File: 3300-BPL

2005-11-28

Subject: **Radio Advisory Board of Canada Response to
Canada Gazette Notice SMSE-005-05 dated 2005-07-30
Consultation Paper of Broadband over Power Line (BPL)
Communication Systems**

Figure 1

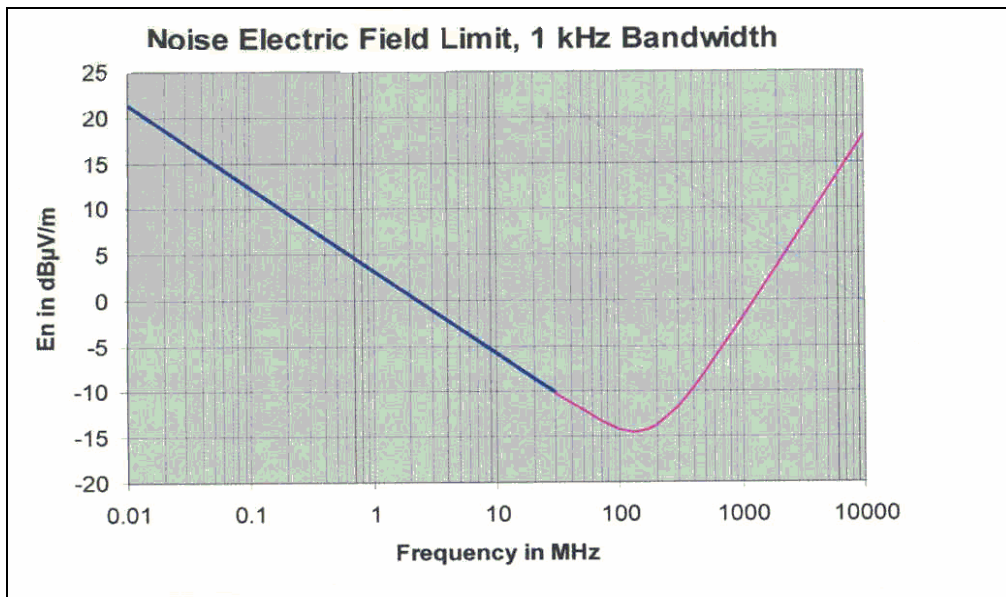
DND's approach follows National Security Agency's, and concurs that emissions from Access BPL in the range 1.8 MHz through 3 GHz shall not exceed those prescribed in Figure 1 when measured at DND's sensitive receiving facilities and radio direction finding stations.

In order to achieve the above levels in Figure 1, DND is in agreement with FCC Part 15 Para 15.615 (F) (3)(i)(C), and requests a **complete** Exclusion Zone radius of 4 km around the following land stations' outer perimeter of the receiving antenna:
